Hi-Fi Products
Service Bulletin

Model: STR-AV570/AV270/AV23

No. 227R2

Subject: Unit Turns On And Off By Itself And The Surround Light Blinks.

(1) FRONT PANEL ASSEMBLY SECTION

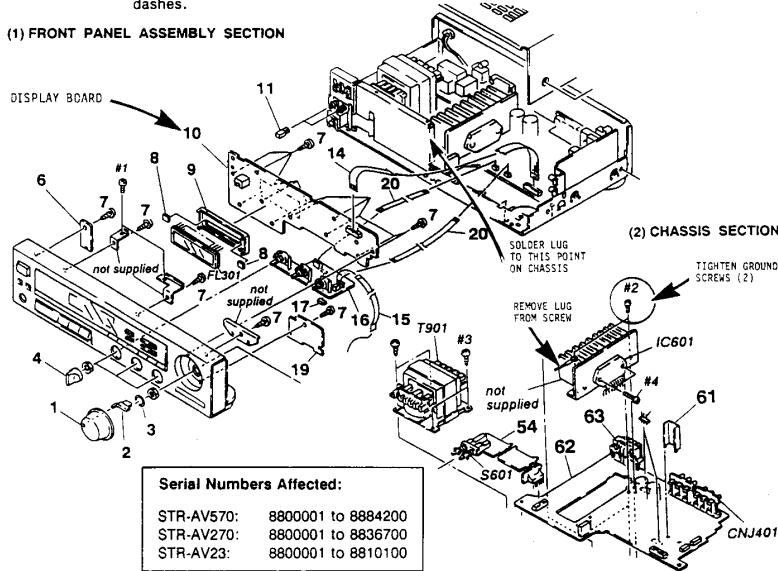
The unit will turn on and off by itself intermittently and the SURROUND indicator blinks.

The ground connection coming from the Display board (Ref. 10) connected to the heat sink is loose. Improve the ground connection from the Display board by soldering the ground lug to the chassis using a high wattage soldering iron. Solder the ground lug to the chassis at the point indicated in the diagram below. It is also necessary to tighten the ground screws securing the heat sink on both sides. Reset the display processor (IC301) by depressing and holding front panel buttons 4, 5 and 6 and powering the unit on. Reset is confirmed in the display by (4) dashes.
